September 1, 2011

**Re: Construction Storm Water Inspection at CCS Georgian Heights Elementary School
Franklin County
Permit Number: 4GC03304*AG**

Figure 1

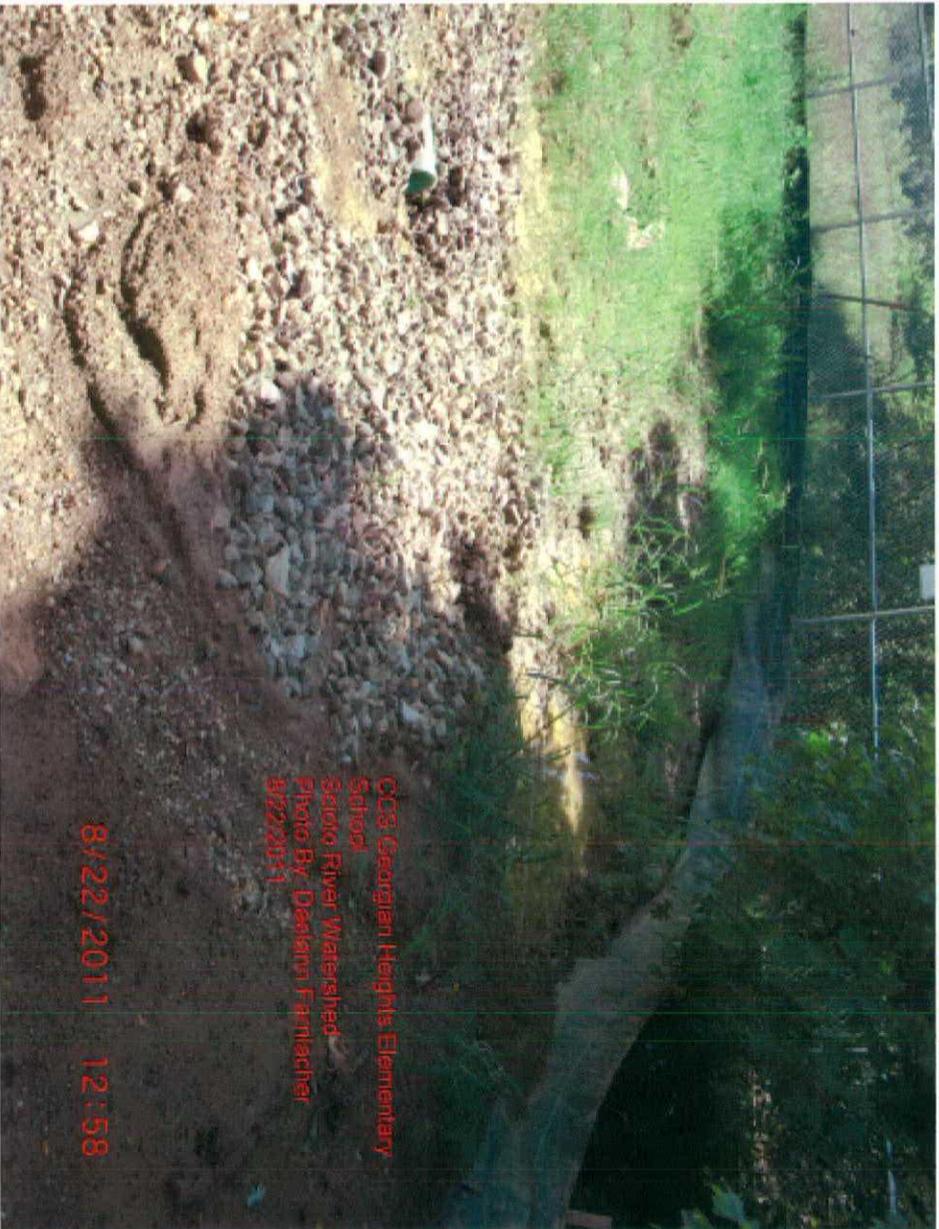
- Be aware the General Permit states that all barren areas which remain idle in excess of 21 days must be protected from erosion within seven days of the last earth disturbing activities. In addition, erosion protection must be implemented for all areas of final grade within seven (7) days.
- Our staff observed the retention pond that has become overburdened with sediment. These sediment impoundments will require cleaning as it appears more than 50 percent of the design capacity is filled with sediment.
- It was also noted that the silt fence near the sediment pond has failed and will require reinstallation to ensure a proper functioning condition (see Figure 1).
